VERMONT YANKEE NUCLEAR POWER STATION
TECHNICAL EVALUATION REPORT OF THE
IPE SUBMITTAL
HUMAN RELIABILITY ANALYSIS

U.S. Nuclear Regulatory Commission
Office of Nuclear Regulatory Research
Division of Systems Technology

Final Report, November 20, 1995

FIGURE 3.3.2
Human Error Probability Response Curves from Swain

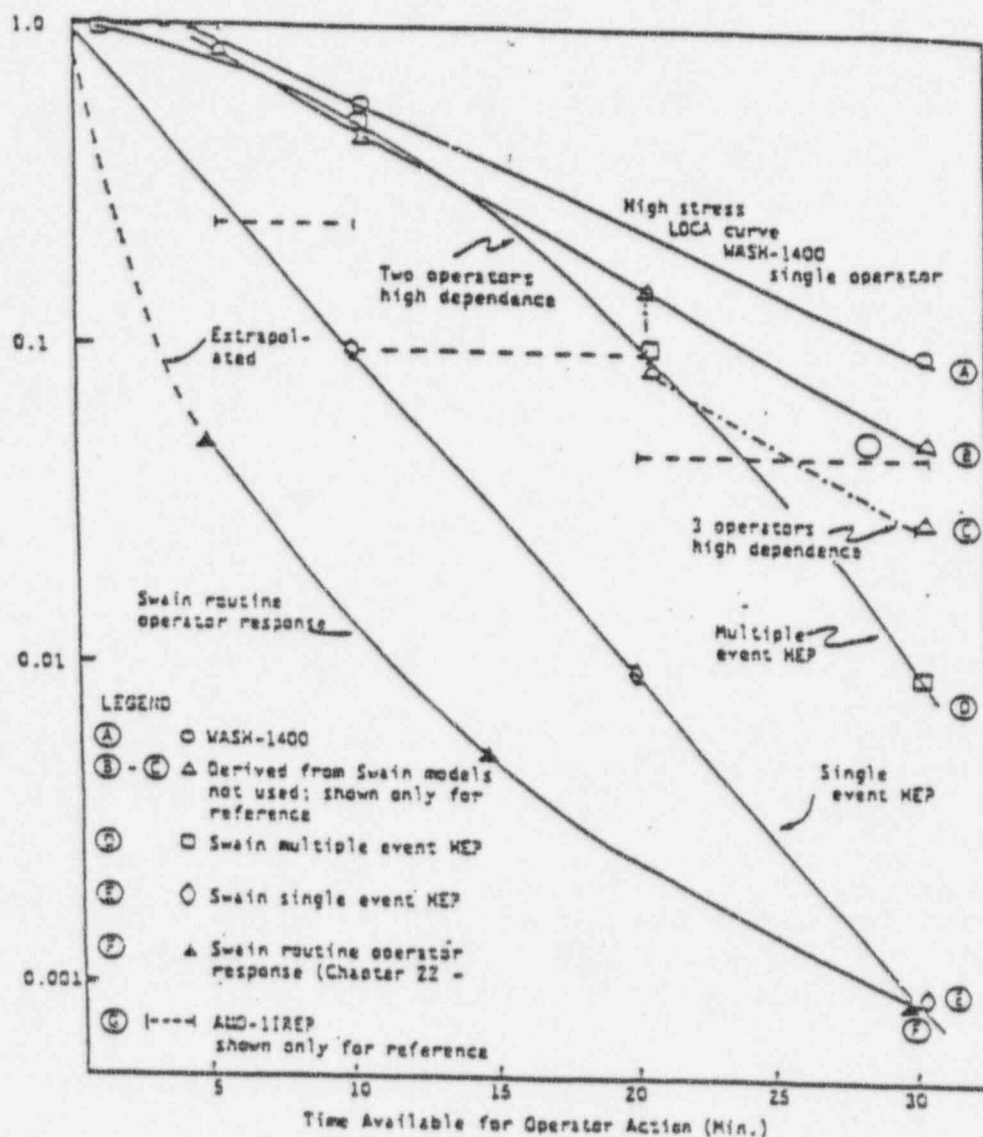
Exhibit A to this report is a reprint of IPE Figure 3.3.2, the time correlation curves used by the licensee to quantify seven (7) operator actions with the VY TRC method. The licensee states that these curves were derived from NUREG/CR-1278 (Reference 2), WASH-1400 (Reference 3), and NUREG/CR-2815 (Reference 4) for different performance shaping factors (PSFs) such as type of action, degree of difficulty, and stress level. Sensitivity to plant-specific factors is not discussed. Curves A through F represent the time-dependent "cognitive" HEPs given various PSFs. Interpolation is performed to quantify HEPs for the medium-term and long-term response times. Generally, the licensee used a HEP value of $1.0E-04$ for medium-term responses and $1.0E-06$ for long-term responses. A manipulative error (taken from the EPRI method) is added to the cognitive HEP to calculate the total HEP for a given action. The specific operator actions quantified with this method are listed in Table 2-1.
